AMENDMENTS TO THE SPECIFICATION

AMENDMENTS TO THE DRAWINGS

REMARKS

Fig-20

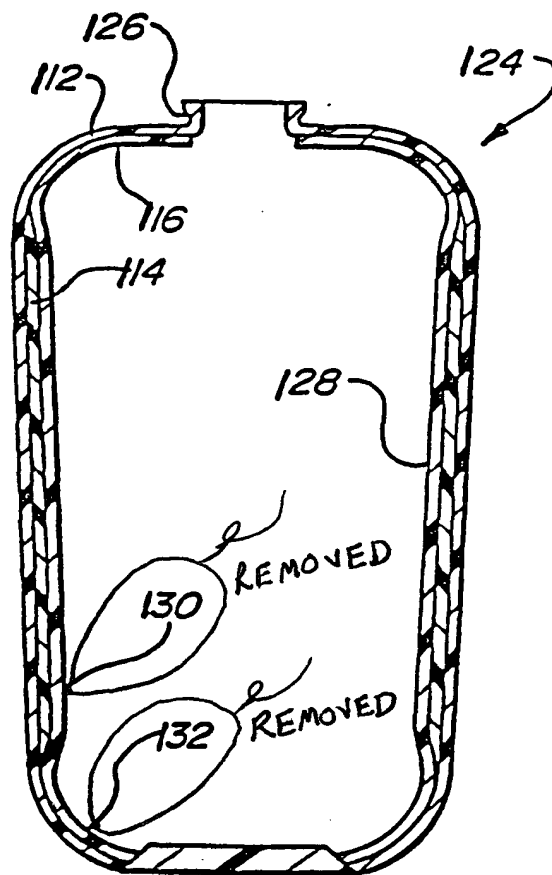
The attached sheets of drawings include changes to Figures 20 and 23. The attached sheets, which includes Figures 19-23, replace the original sheets including Figures 19-23.

Reference signs 130 and 132 appear in Figure 20 but are not mentioned in the description. Reference sign 170 appears in Figure 21 but is not mentioned in the

description. Applicants present replacement figures in which reference signs 130, 132, and 170 have been removed.
